**City of St. Helena
Planning Commission
Regular Meeting
Tuesday, October 18, 2022 @ 6:00 PM
Vintage Hall Board Room - Second Floor
465 Main Street, St. Helena**

- 5.1. Request by Sasha Janev on behalf of Lorraine and Joe Berchtold for adoption of a resolution approving a demolition permit and design review to demolish an existing residence and accessory structures to accommodate the construction of a new single-family home and accessory dwelling unit on the property located at 2126 Madrona Avenue in the Medium Density Residential zoning district.

**CITY OF ST. HELENA PLANNING COMMISSION
RESOLUTION NO.
GRANTING DEMOLITION PERMIT AND DESIGN REVIEW APPROVAL TO
2126 MADRONA AVENUE (File No. PL21-044)**

SHEET: C2.0

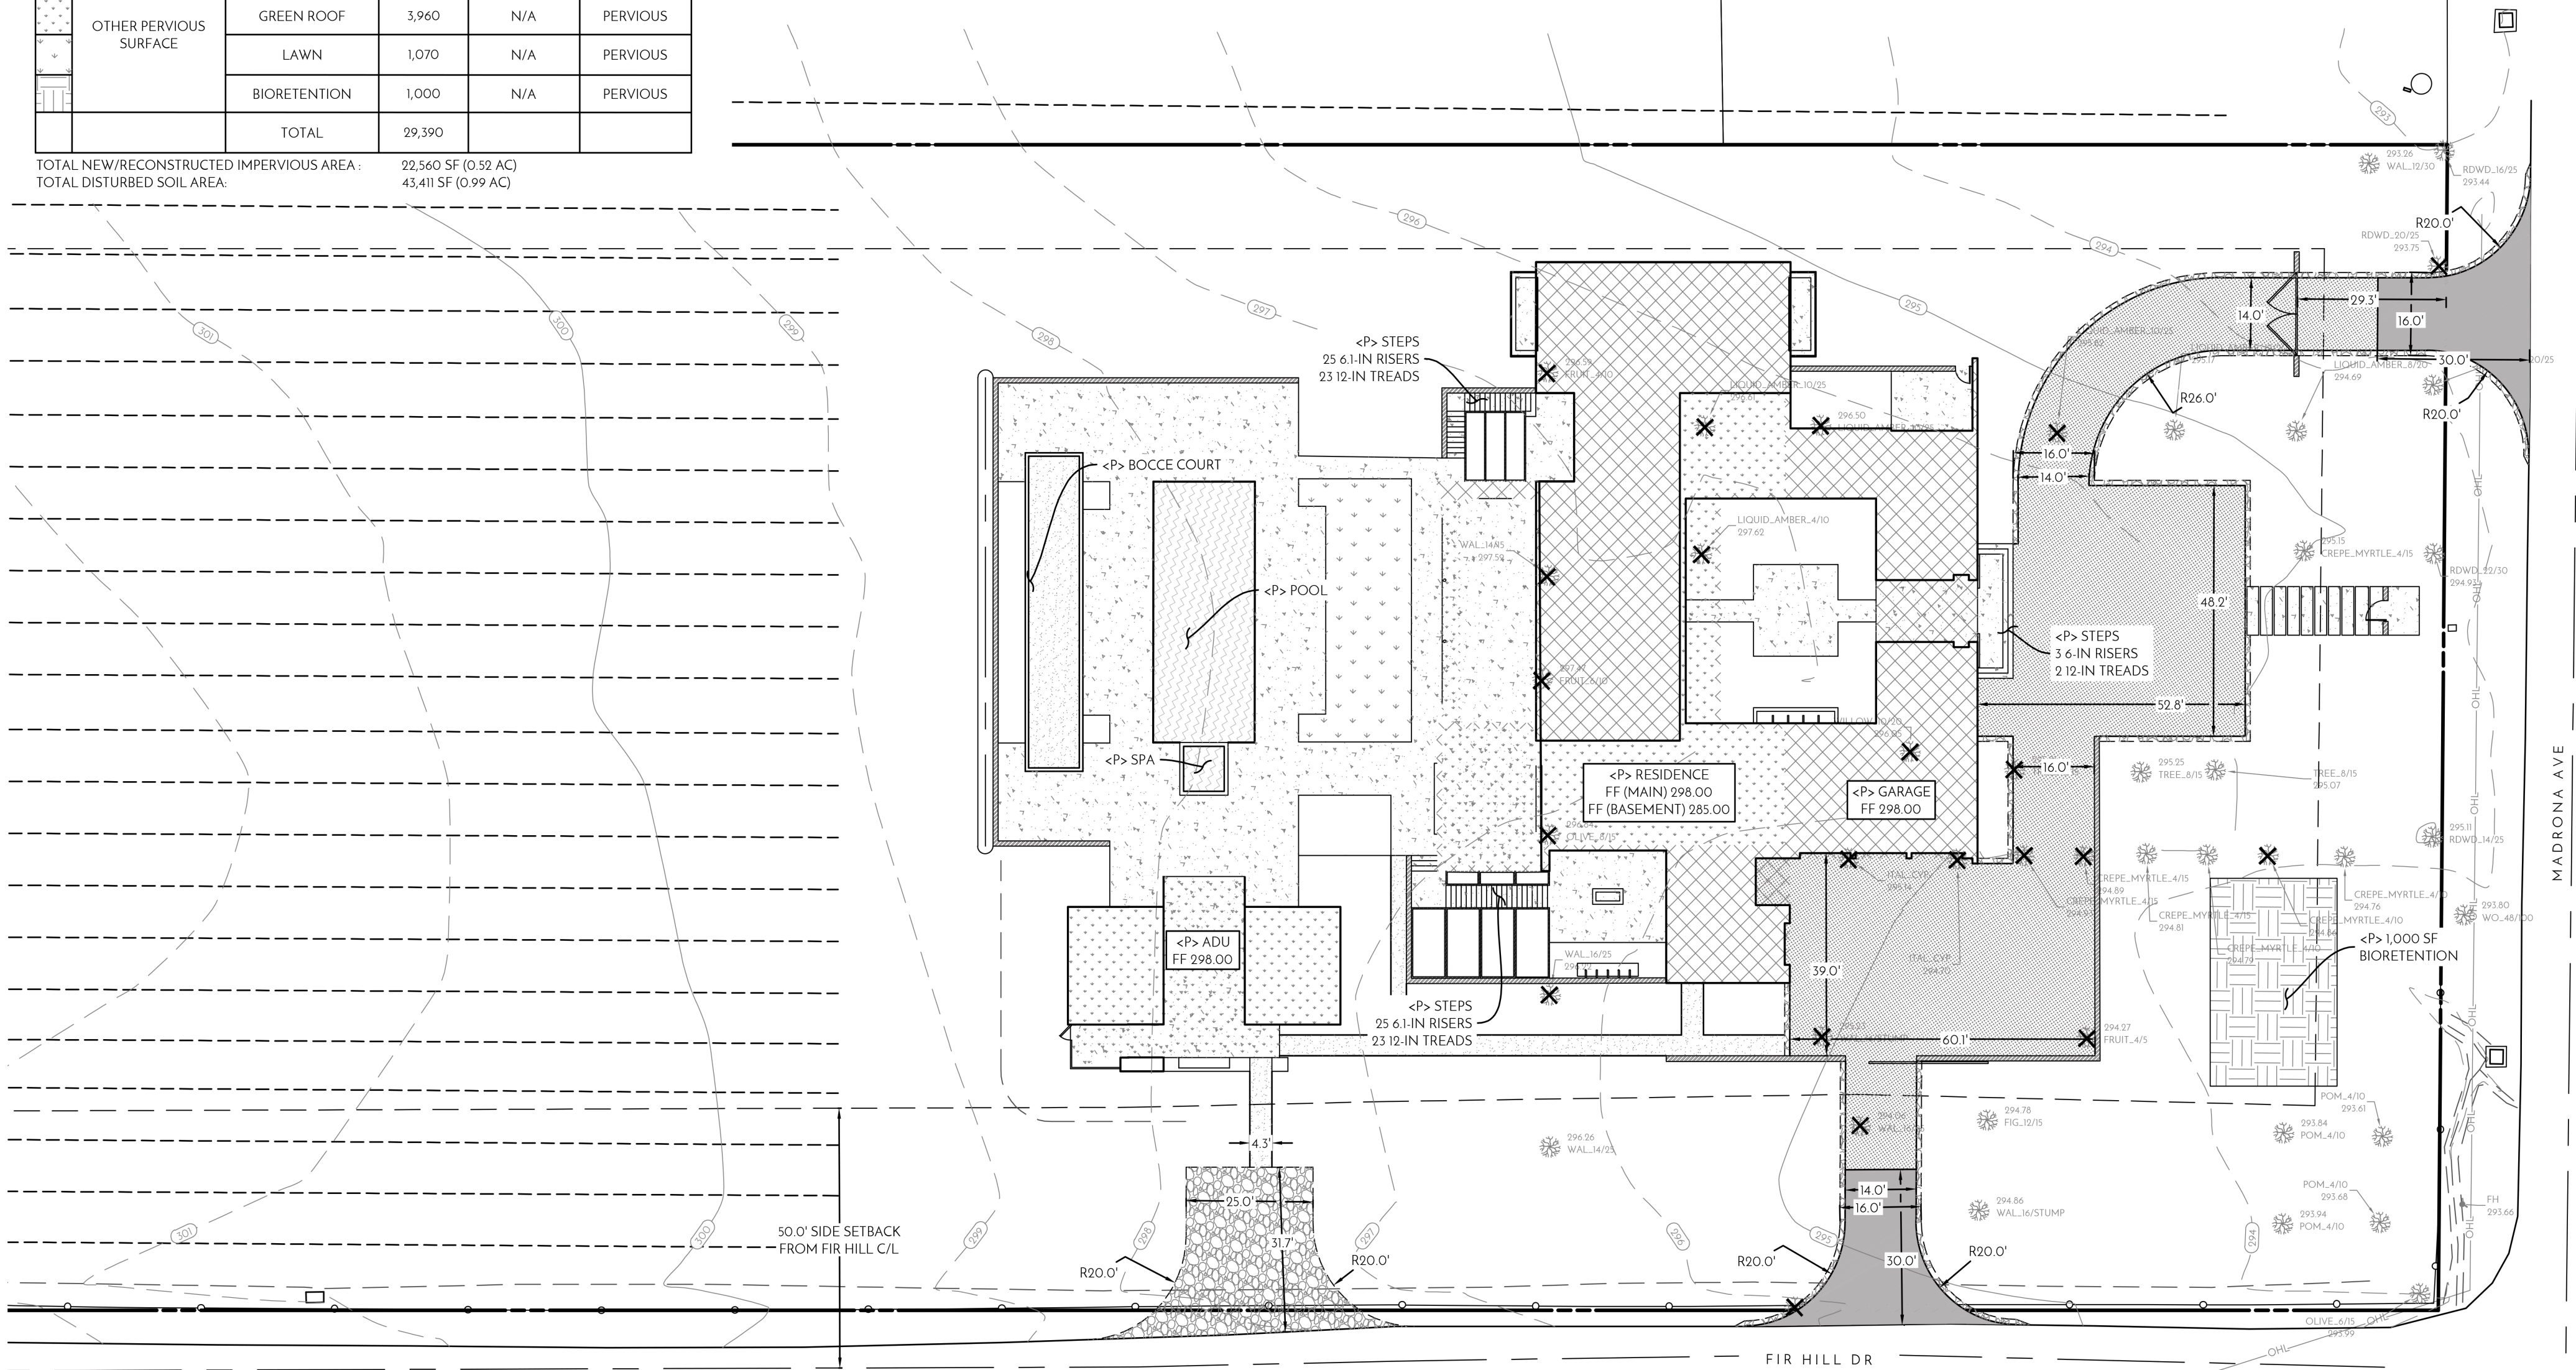
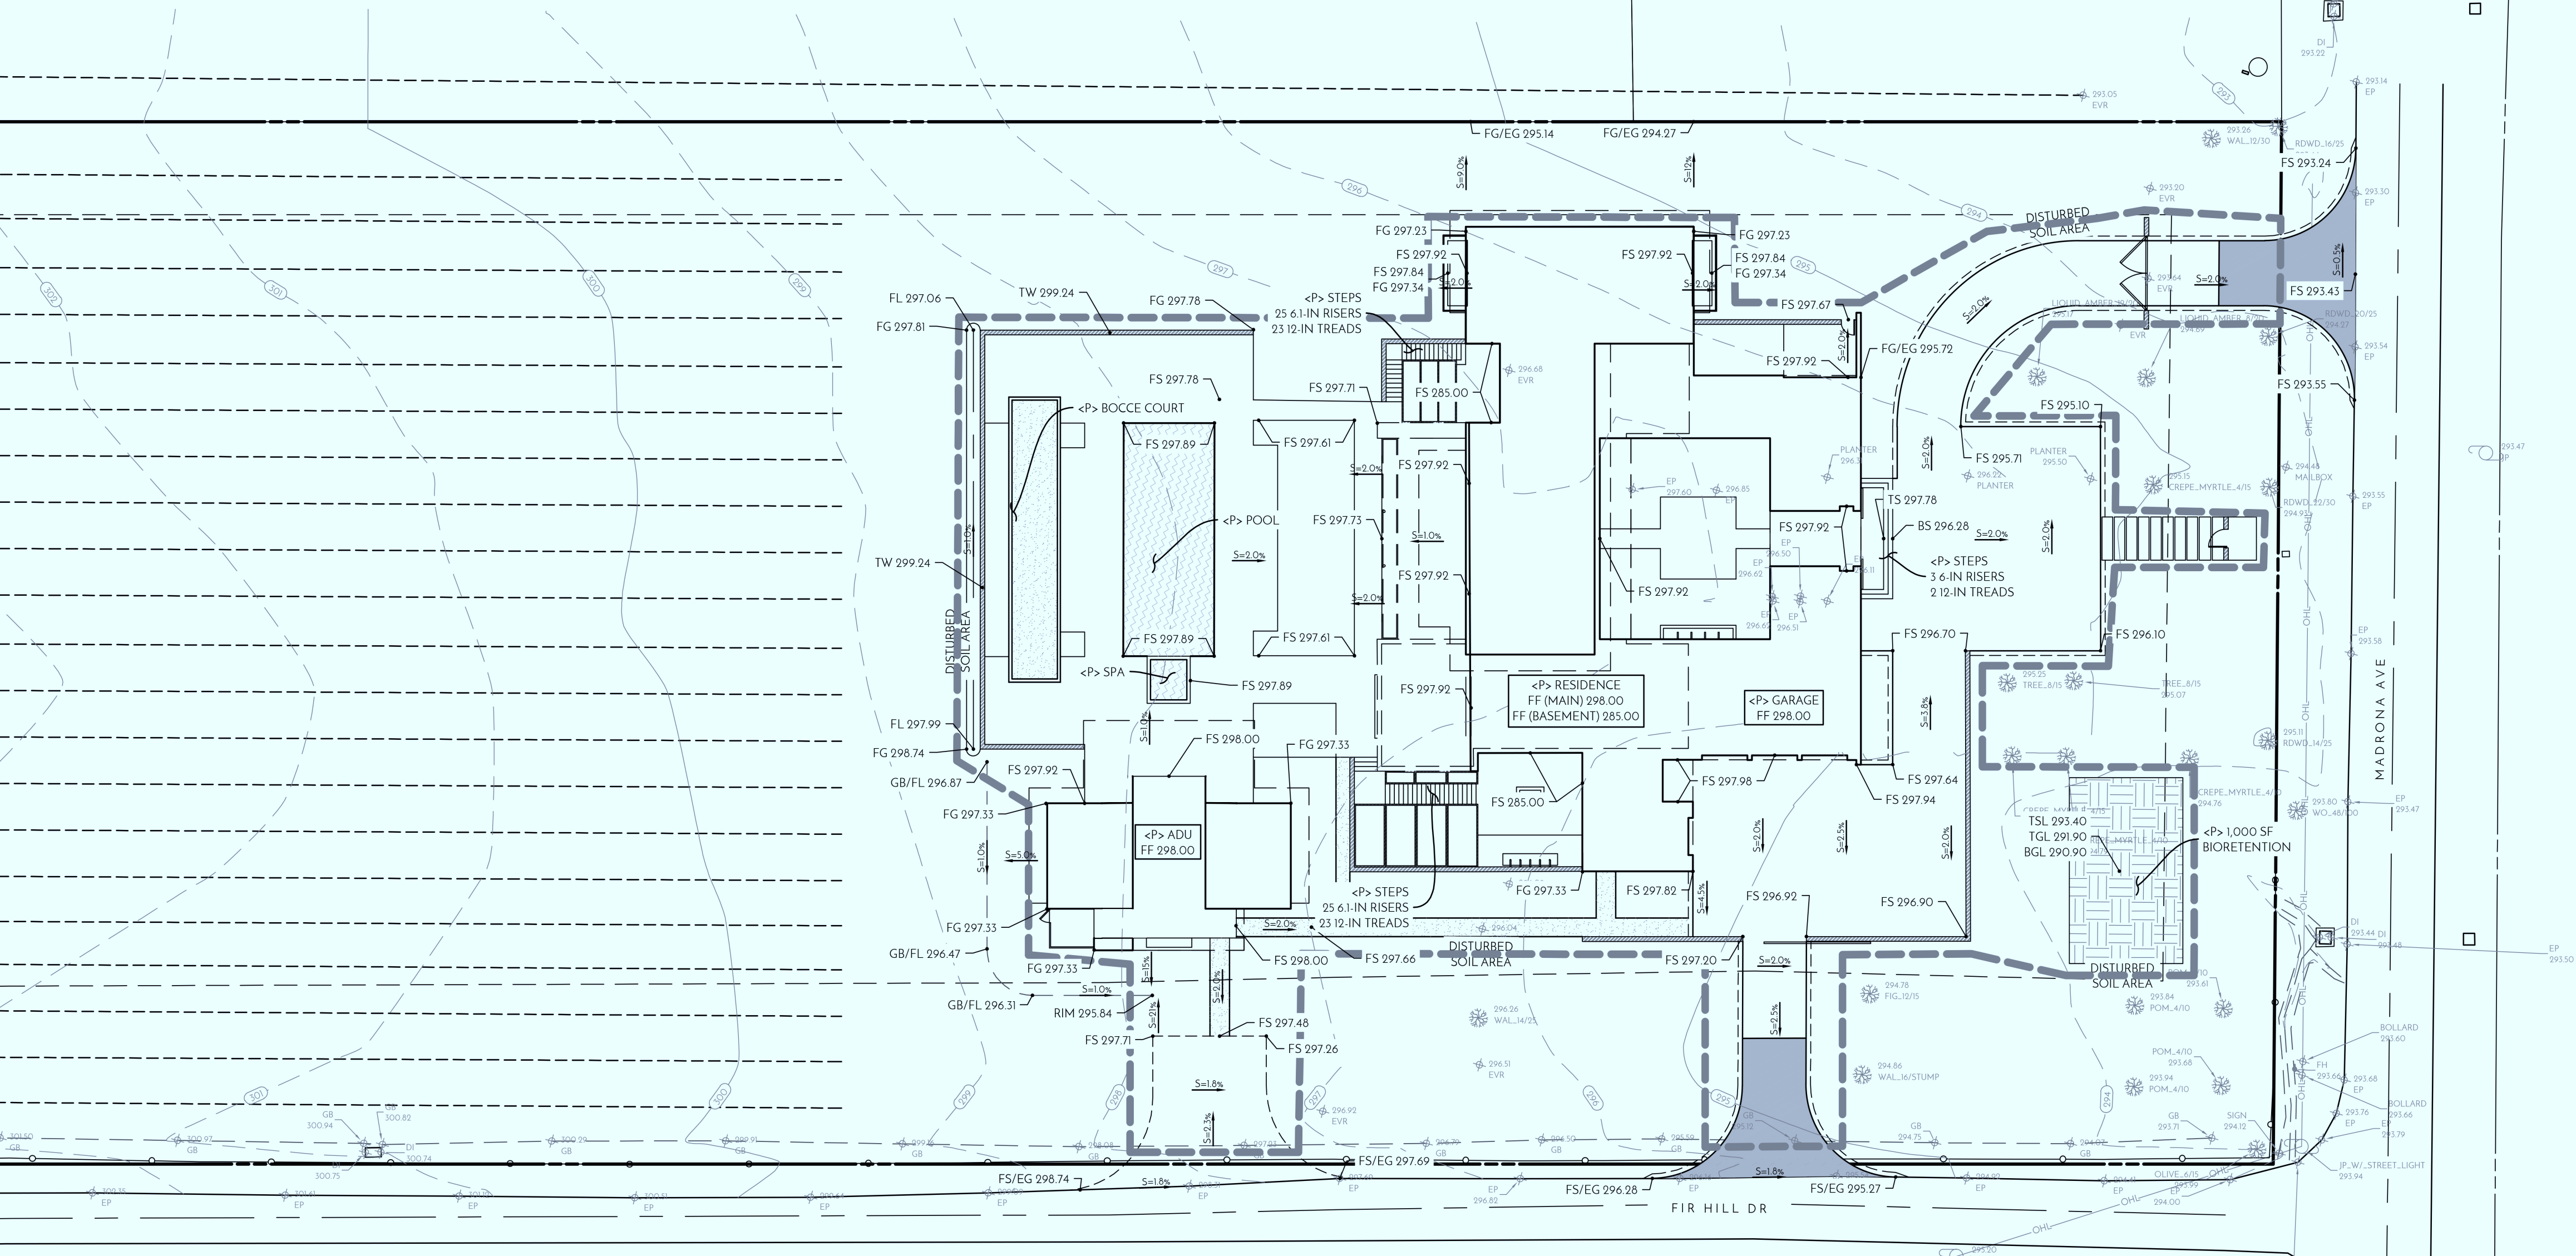
Sheet C2.0 – Hardscape and Grading Plan of the project plan set indicates that two 100 square foot bioretention areas will be installed on the project site, one at the front of the property and one at the rear of the property. These measures will provide adequate drainage and detention to mitigate flooding from increased stormwater runoff attributable to the development.

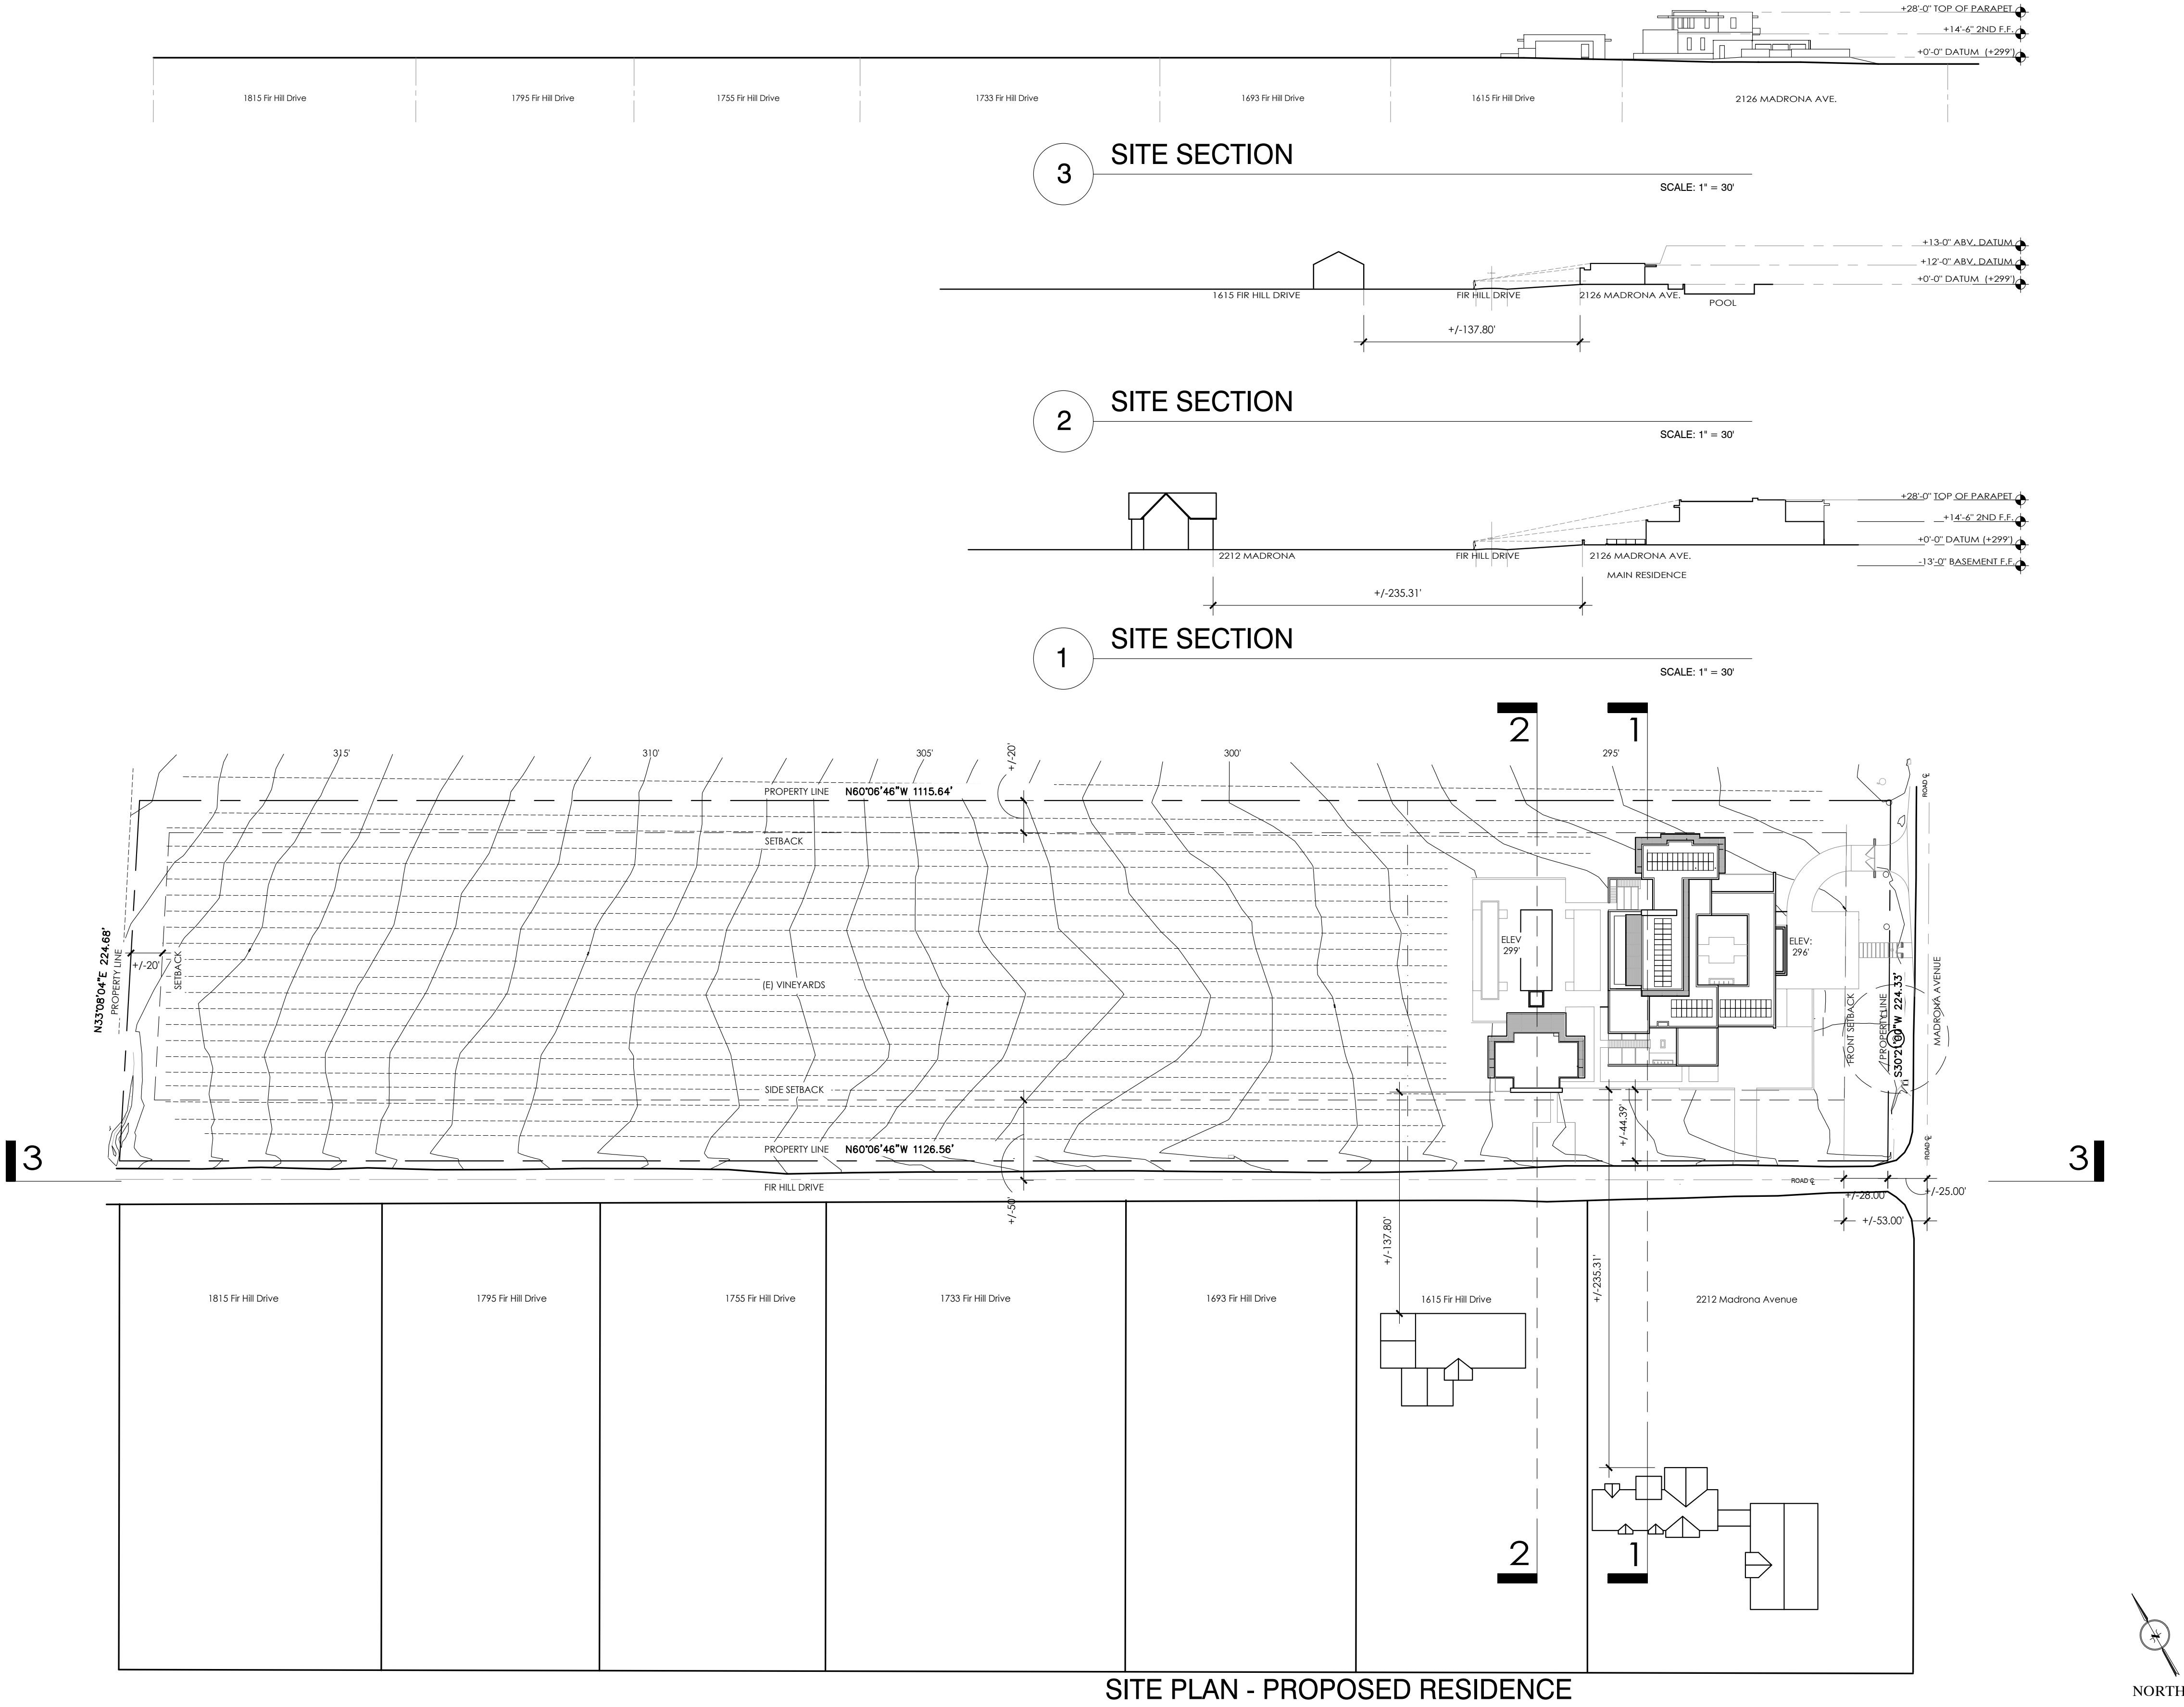
3. The Site Plan Proposed Residence (A1.2 and A1.3) attempts to show the locations of the Madrona and Fir Hill residences most affected in relation to this project. The residence outlines for 2212 Madrona and 1615 Fir Hill on these pages are not representative of the actual locations of these homes. They are shifted too far North which makes it appear as the view impact is smaller than reality.
